Power Steering Actuator Repair Kit – P/N 811632

1991 Mariner Mag II
with Optional Power Steering

1991 Mercury XR4
with Optional Power Steering

Power Steering Kits P/N 17443A _ _

a - Parts Included In Repair Kit P/N 811632
b - Actuator Seal

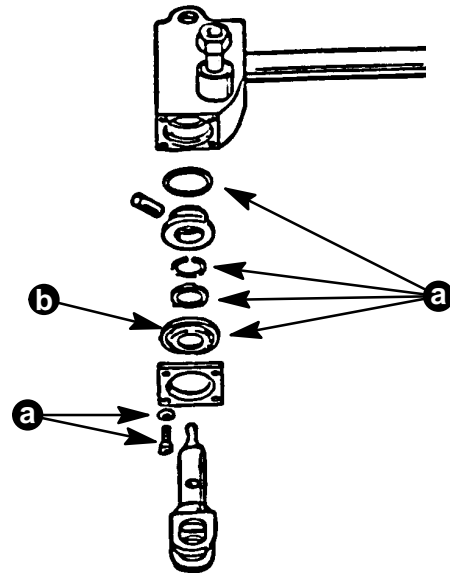
Previously, any repair of the power steering system for an actuator seal failure consisted of either reusing the old seal or replacement of the complete power steering cylinder. Now an actuator seal kit is available.

Oil leaking from the actuator seal due to blow-out can be repaired by installing the original seal if it is not damaged. Before operating the steering system again, it is necessary to correct the cause of the high pressure which resulted in the seal blow out.

Seal blow-out can be caused by:

- Overfilling the reservoir.
- Extending or retracting the steering ram prior to removing the factory installed plastic plugs in the steering cylinder and actuator head.
- Return hydraulic line that is kinked or pinched.

New actuator seal parts are available in actuator repair kit p/n 811632. This repair kit includes O-rings, seals and screws necessary to reseal the actuator.

Apply Loctite 271 (type A) to the threads of the new screws and torque to 25 Lb. In. (2.8 N.m).

After resealing the actuator, inspect the steering system for potential kinking of hydraulic lines. Check throughout the full steering and trim/tilt ranges of the outboard.
